# ADDENDUM No. 1

## ITB No. 4525

### CREST BUENA VISTA WASHINGTON WATER MAIN PROJECT

SHEET No. **34 OF 46**

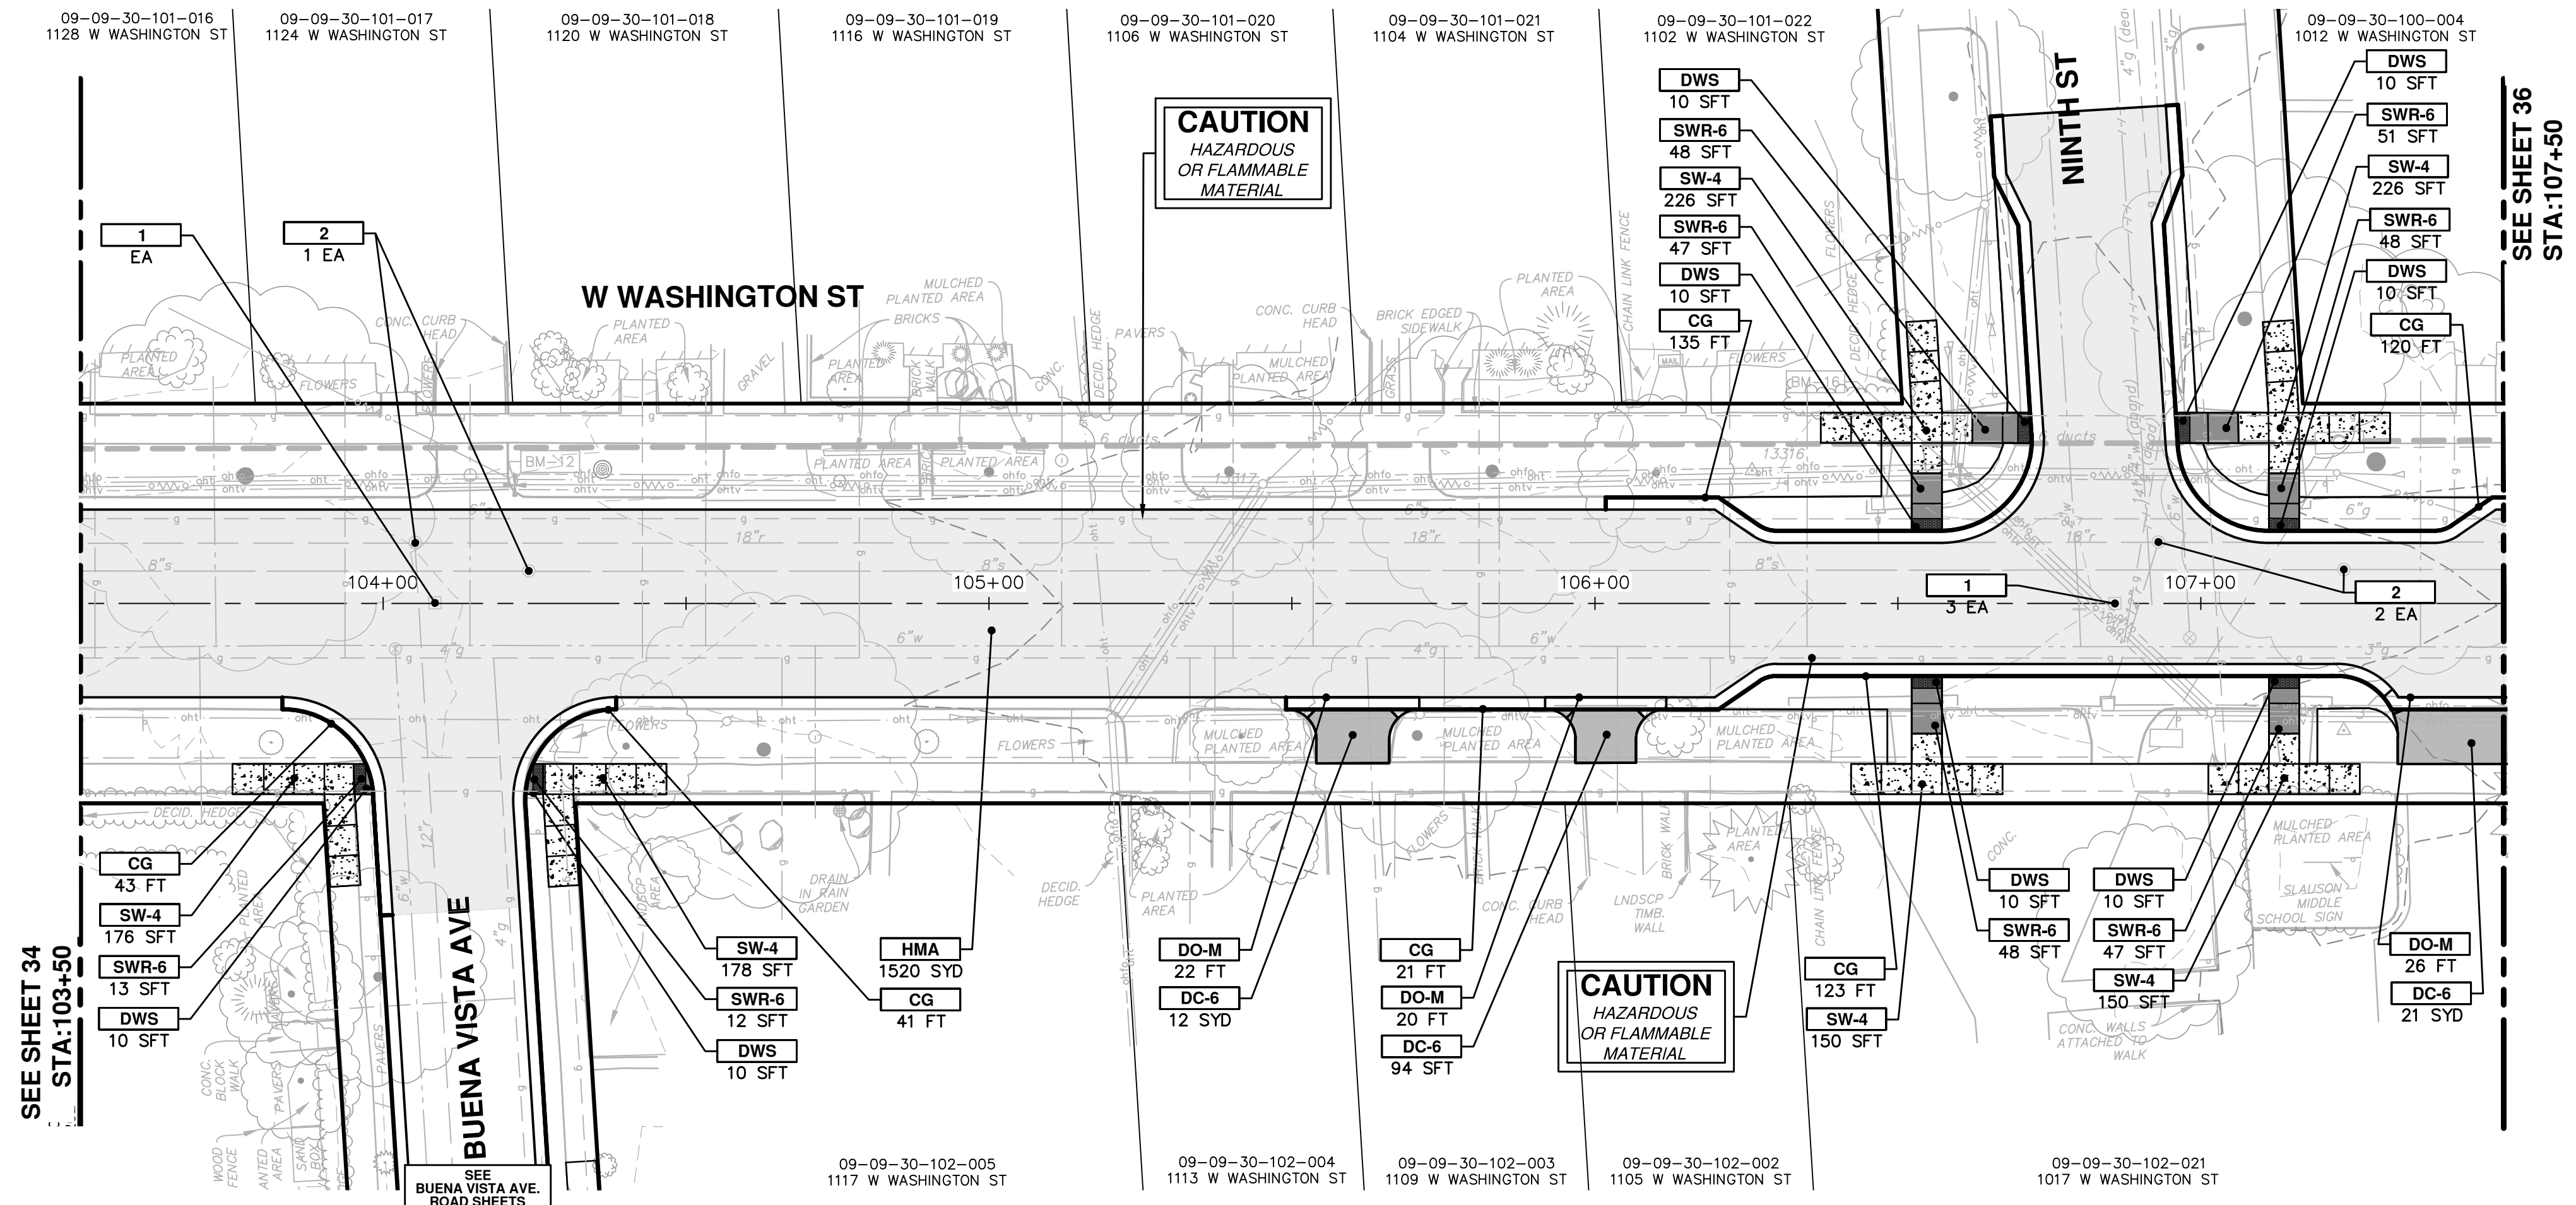
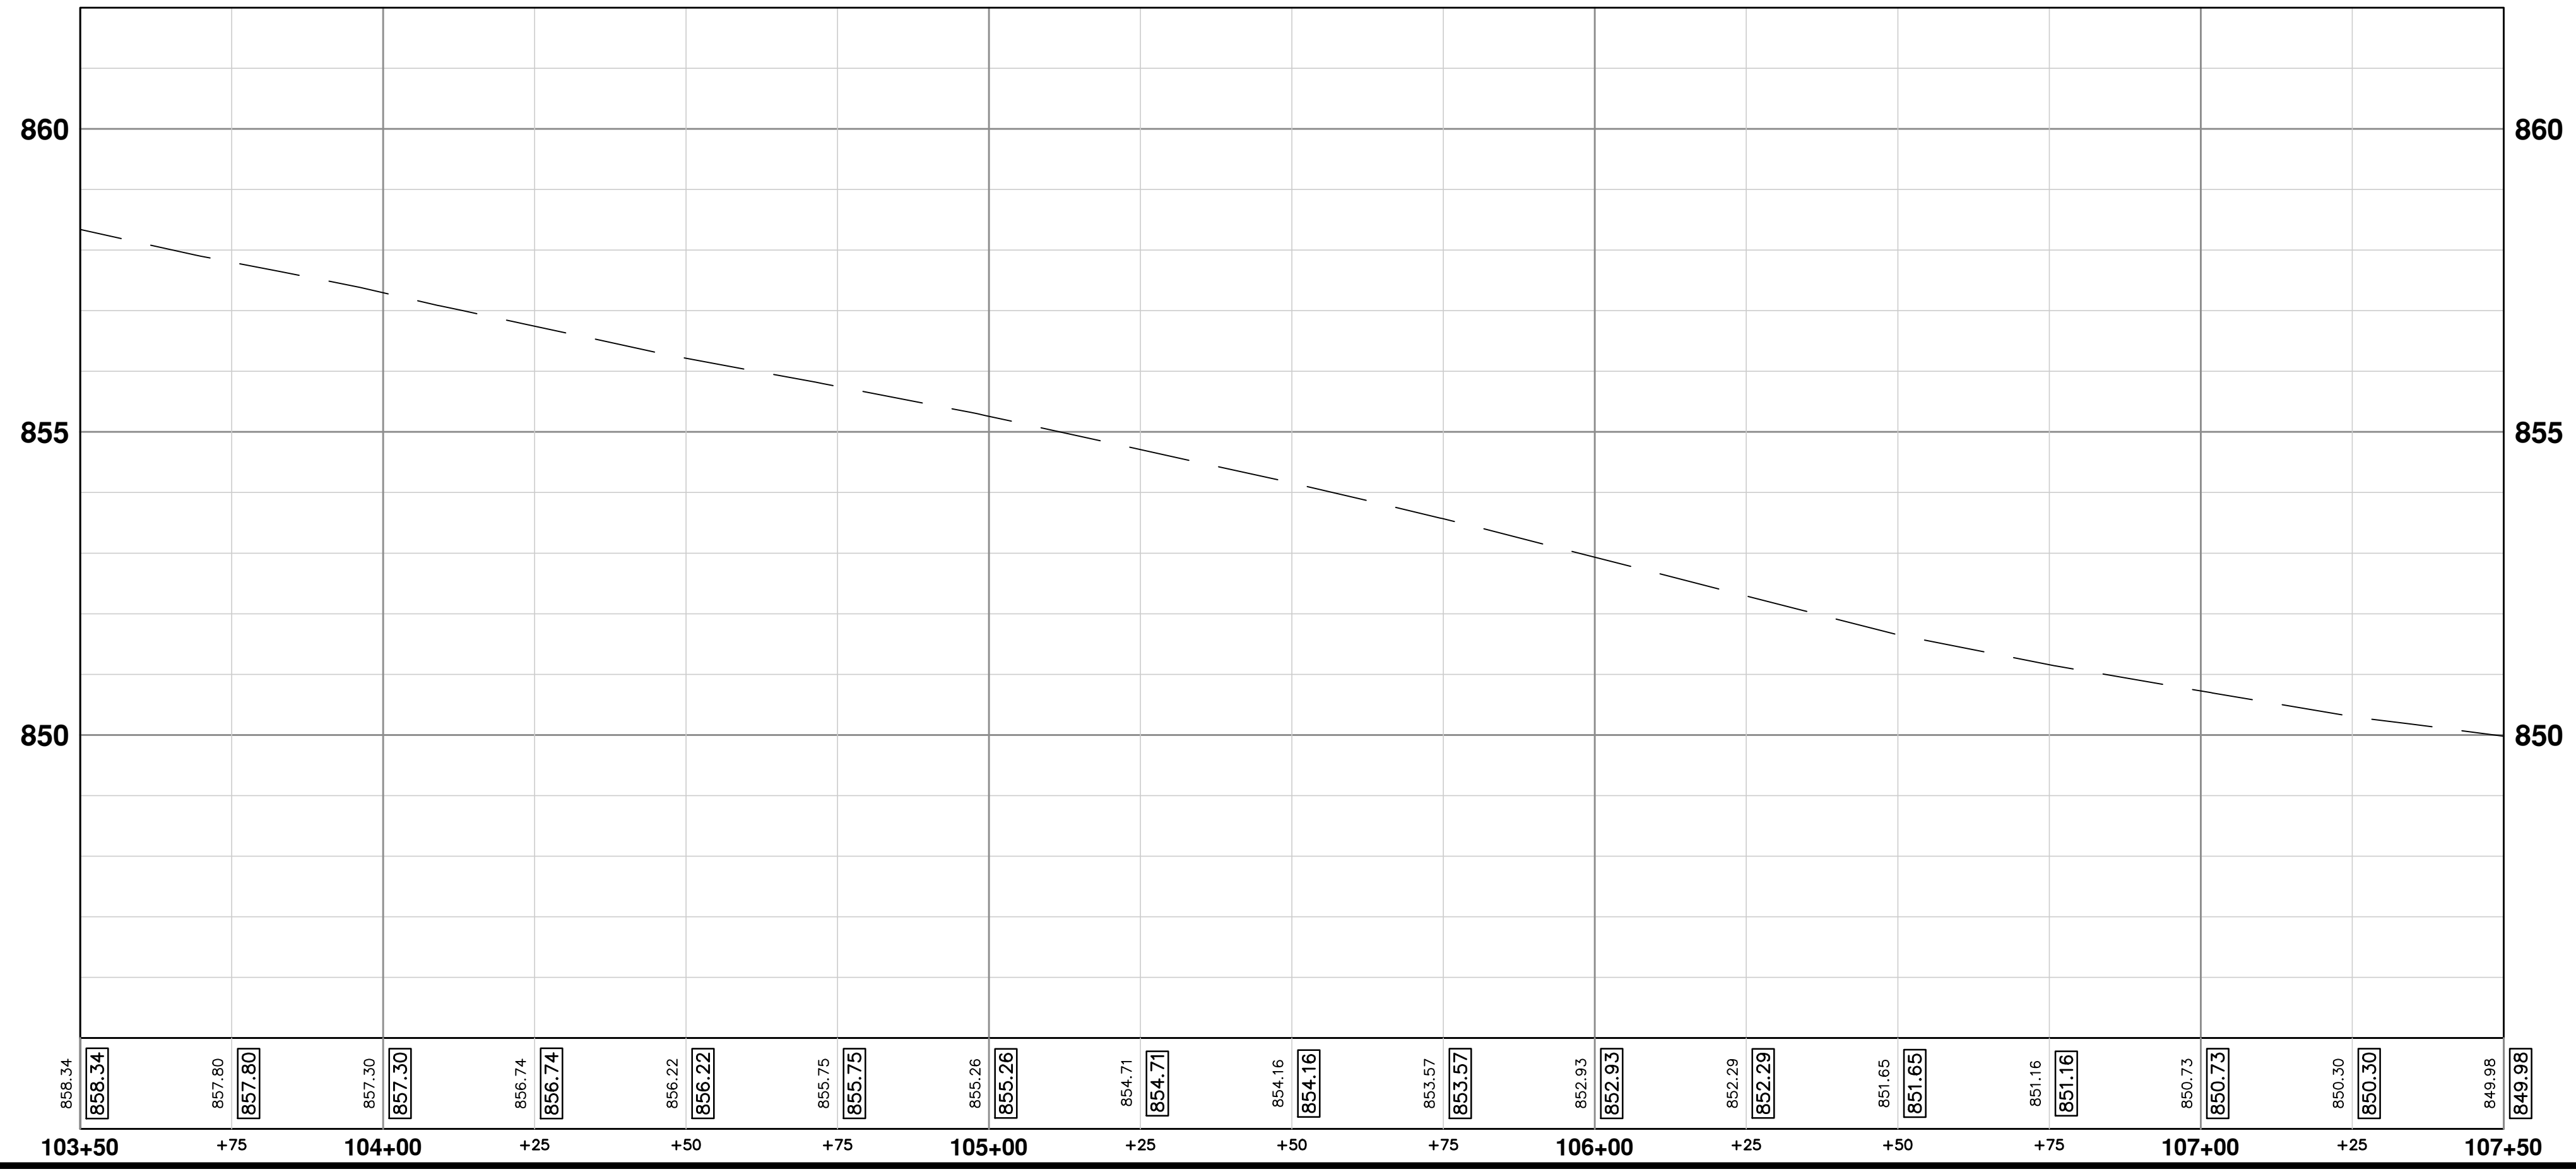
On plan sheets 34 and 35, proposed storm features were added and multiple proposed driveways, M-openings, and curb & gutter were eliminated from Washington station 0+00 to 10+00.
